McLaren Artura - HVAC Drain Hose Retention Enhancement

Bulletin type: Service Campaign
Reference number: N/A
Campaign reference: SCB 16 N 001
Attention: Retailer Aftersales Managers, Retailer Service Managers, Retailer Service Advisors, Retailer Technicians, Retailer Parts Managers
Affected vehicles: McLaren Artura
Situation: HVAC drain hose retention enhancement
Procedure: Action affected vehicles during next Retailer visit. Please refer to the information outlined in this document to complete the required work
Date: 10 October 2023

Image 1 HVAC drain hose location (1)

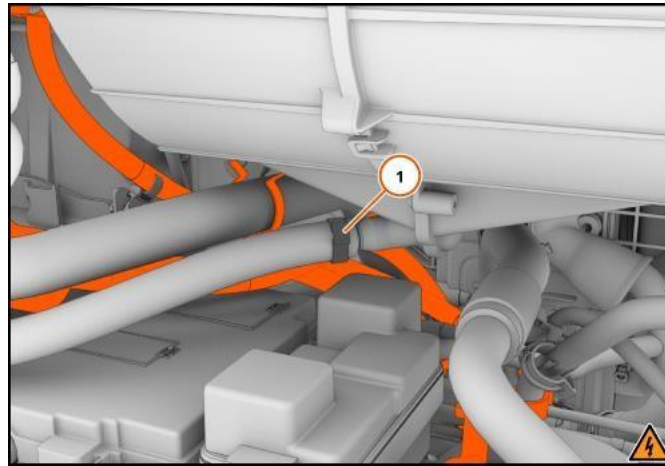
Through continuous product quality monitoring, McLaren Automotive has identified that in certain McLaren Artura vehicles, the Heating, Ventilation, and Air Conditioning (HVAC) drain hose may not be correctly retained. To rectify this a rework procedure has been released to ensure the correct retention clip and insert are fitted to the hose.
